**STAFF REPORT
CORRESPONDENCE ITEM**

CASE NUMBER: P.D. 06-314 CC L.U.C.B. MEETING: July 10, 2008

DEVELOPMENT NAME: Lee Line Farms Planned Development

REQUEST: Site Plan Approval for a Wal-Mart Super Center consisting of 151,908 square feet of floor area

Proposed Detailed Site Plan

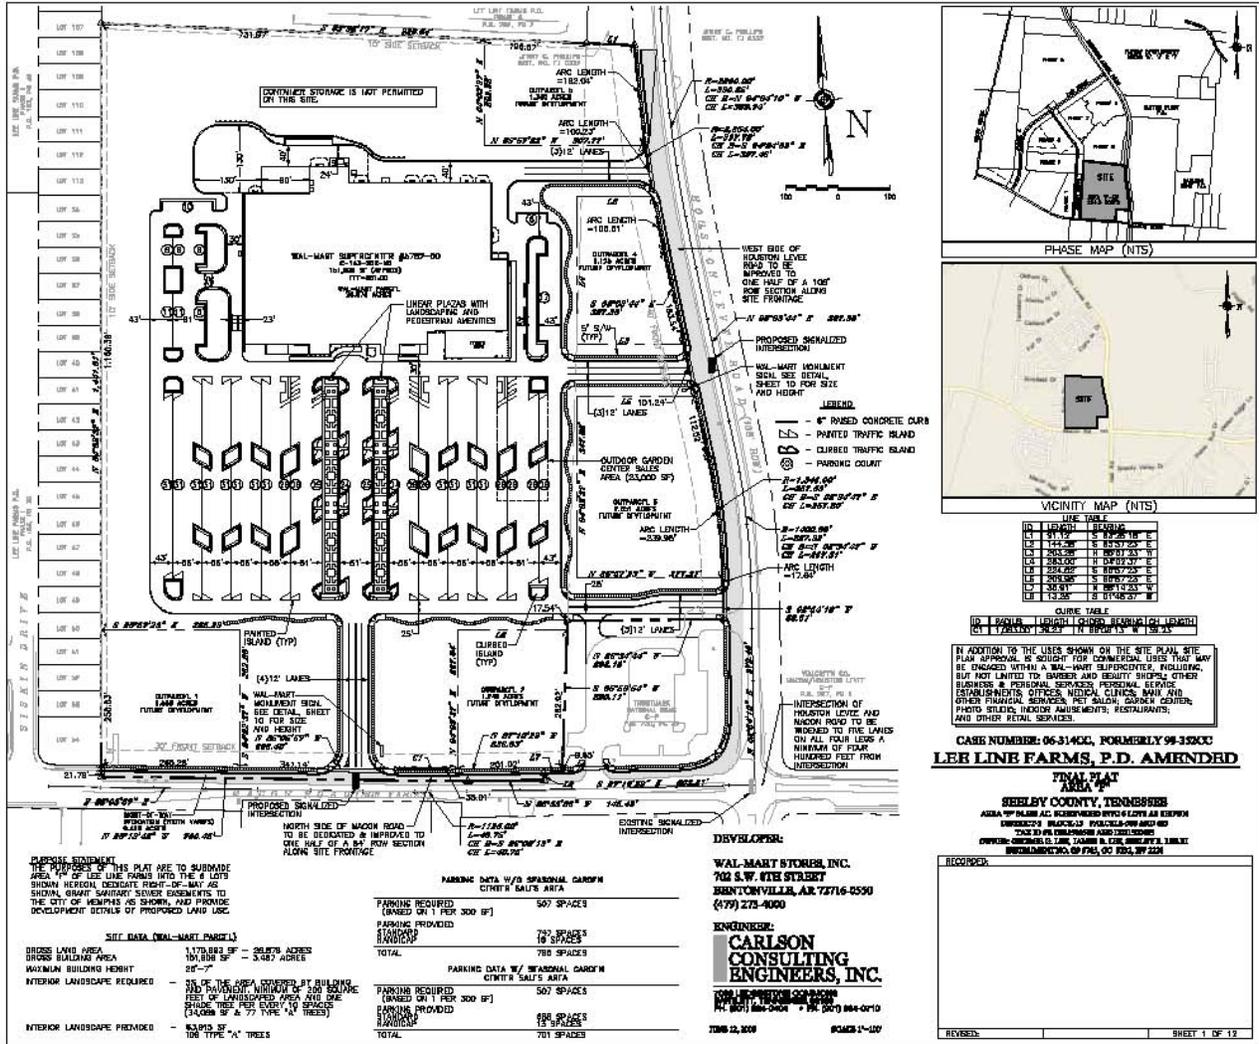
Buffer Increase Along West Property Line: The Outline Plan Conditions currently require a minimum buffer of 60 feet along the west property line abutting the single-family homes along Siskin Drive. The previous site plan submittal established 80 feet. The newest site plan establishes a minimum buffer area of 92 feet. The OPD Staff has always requested that the proposed supercenter building be moved as far east as possible to lessen the impact on the Siskin residences and increase the buffer area.

Supercenter Building Relocation Further East – The OPD Staff has always requested the supercenter building be re-oriented away from the Siskin Drive residents. The previous submittal was 225 feet from the west property line with the drive-through pharmacy being located 200 feet from the property line. The current site plan locates the building 270 feet from the west property line with the drive-through pharmacy being 245 feet from the western property line. This is 155 feet further away from the Siskin homes than is what is shown on the approved Concept Plan recorded with the Outline Plan for Area F.

Landscaping Island Additions – Large landscaped islands have been added to the western side of the property to enhance screening of the building from the Siskin homes to the west.

Linear Plaza Addition – Two linear plazas have been added the length of the front parking lot along Macon Road. These include pedestrian walkways, benches, planters, and pedestrian-scale lighting.

Parking Space Reduction – The previous site plan submittal contained 825 parking spaces. The current submittal contains 765 spaces. According to the applicant, the concept plan recorded as part of the Outline Plan contains 1,046 parking spaces.

1. A minimum building setback of 270 feet shall be provided along the west property line with the exception that the drive-through canopy for the pharmacy shall be permitted a minimum setback of 245 feet.

2. A minimum building setback of 250 feet shall be provided from the north property line.
3. No outparcel shall have a curb cut to either Macon Road or Houston Levee Road. Each outparcel shall gain access through the internal drive system serving the Wal-Mart Supercenter.

Proposed Detailed Landscaping Plan

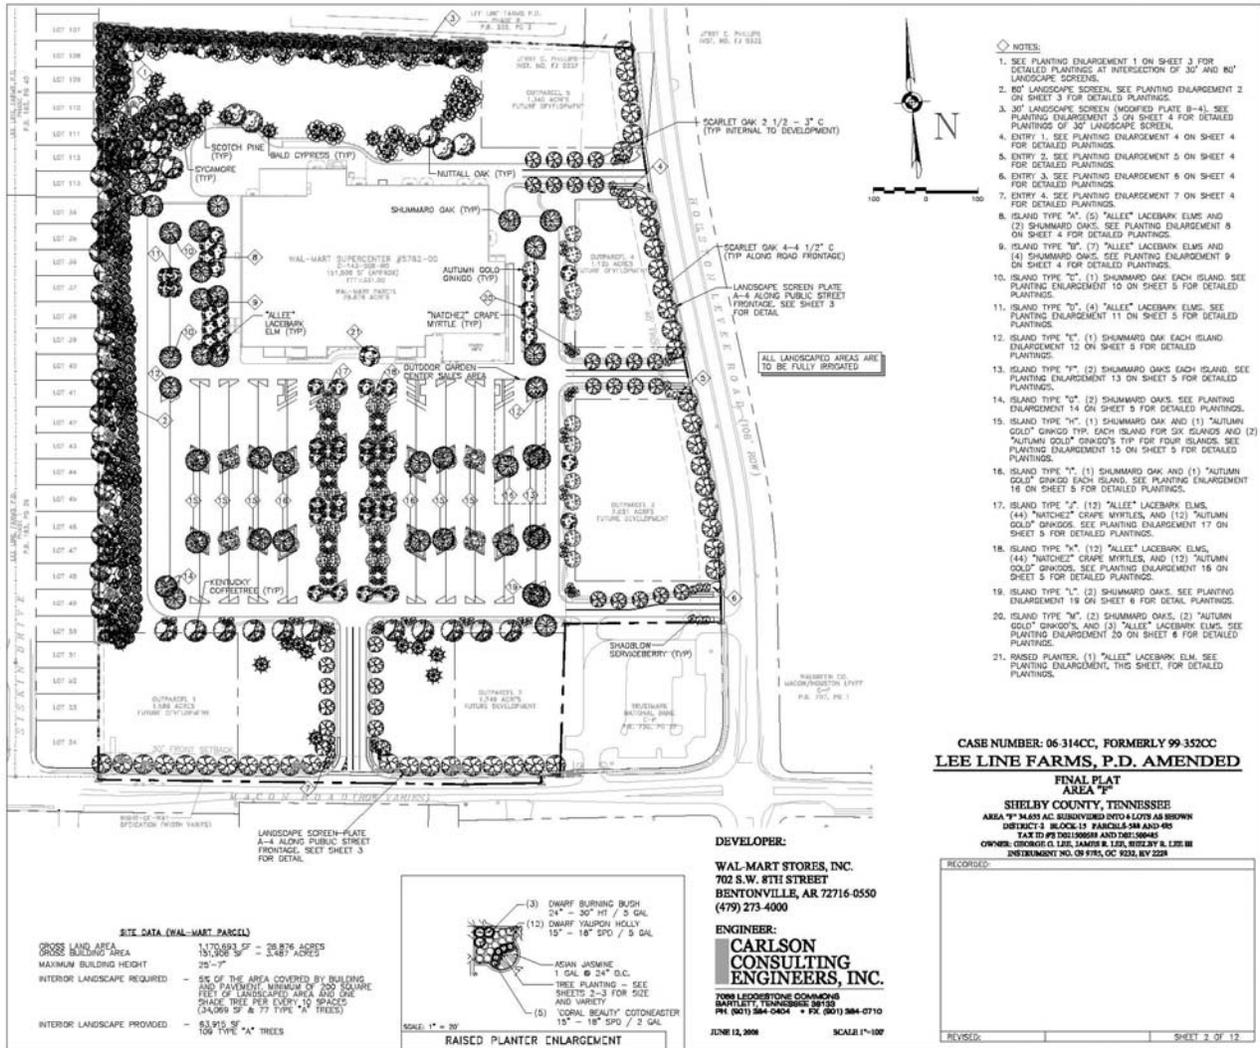
Parking Lot Landscaping and Large Tree Installation – The Outline Plan requires that at least 5% of the parking lot areas be landscaped. The revised plan provides 9.38%. In addition, 40% more large trees are being installed than is required.

4. All landscaping illustrated on the proposed landscaping plan including those planting areas around each outparcel shall be installed prior to the issuing of a Use and Occupancy Permit for the Wal-Mart Supercenter.

5. The north property line of Outparcel 5 shall be landscaped with the same landscaping pattern proposed along the north property line of the Wal-Mart Supercenter as part of the landscaping plan to be installed prior to the issuing of a Use and Occupancy Permit for the Wal-Mart Supercenter (30 feet wide/Modified Plate B4).

6. A landscaping screen subject to the approval of the Office of Planning and Development shall be installed along the west property line of Outparcel 1 as part of the landscaping plan to be installed prior to the issuing of a Use and Occupancy Permit for the Wal-Mart Supercenter (to be 80 feet in width except where approved for reduction by OPD due to existing utility installation) .

7. Berming shall be used as part of the landscaping screen between the west property line and the Wal-Mart Supercenter Building and parking lot as illustrated by the landscaping plan subject to the approval of the Office of Planning and Development.

FIGURE 8
RECOMMENDED IMPROVEMENTS

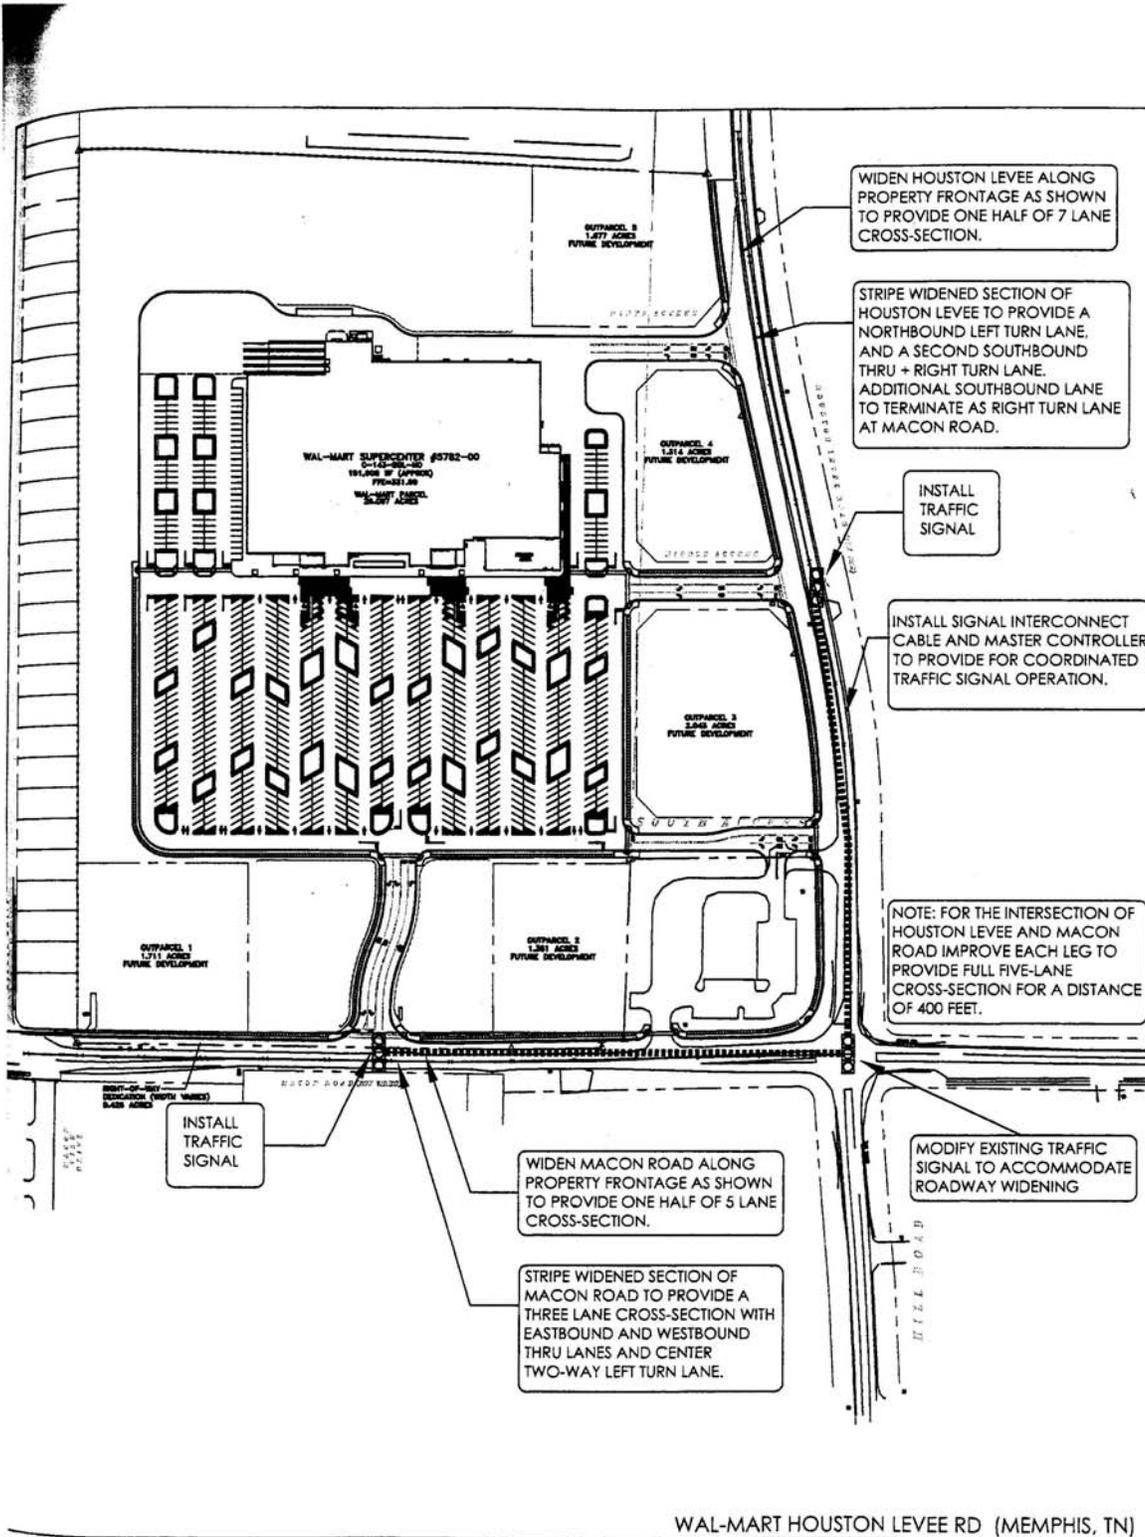
The traffic counts for the study were taken during the time school was not in session for Macon-Hall Elementary which is immediately west of the subject property on Macon Road and is well known to area residents for its back up of traffic in the mornings and afternoons when school is in session. This seems to be a deficiency in the study.

The OPD Staff has recently met with the County Engineer to discuss the traffic study. The conclusion of the County Engineer is that while the offer by Wal-Mart to extend full roadway improvements in all four directions at the intersection for up to 400 feet in each direction is good, the proposed supercenter development will nonetheless create demands on county infrastructure that cannot be met in the foreseeable future. It was suggested by the County Engineer that if the project were approved, conditions be added to assure full 5-lane road improvements in all directions at the intersection up to 800 feet.

The analyses presented in this study indicate that the traffic generated by the site can be accommodated with certain traffic control and roadway improvements. These improvements are shown in Figure 8 and are described as follows:

- **Widen Houston Levee Road** - Widen Houston Levee Road along project frontage to provide one half of a seven lane cross-section. The widened section of Houston Levee Road should be stripped to include a northbound left turn lane and a second southbound thru + right turn lane. The additional southbound lane should terminate as a right turn only lane at Macon Road.

- **Install Traffic Signals** - Recommend installation of a traffic signal at the intersection of Houston Levee Road and the middle project access. A traffic signal is also recommended for the intersection of Macon Road and the Wal-Mart driveway access.

- **Install Signal Interconnect Cable** - To provide for coordinated signal operation, fiber-optic communications cable should be installed between the proposed Wal-Mart traffic signals and the existing traffic signal at Macon Road and Houston Levee Road. In addition, a master controller should be provided.

- **Modify Existing Traffic Signal** - The existing traffic signal at the intersection of Macon Road and Houston Levee Road will need to be modified to accommodate the roadway widening.

- **Widen Macon Road** - Widen Macon Road along project frontage to provide one half of a five lane cross-section. The widened section of Macon Road should be marked as three lanes to include eastbound and westbound thru lanes and a center two-way left turn lane.

- **Additional Intersection Widening** - To address County staff concerns, widen the intersection of Houston Levee and Macon Road to a five lane cross-section for 400 feet in all four directions.
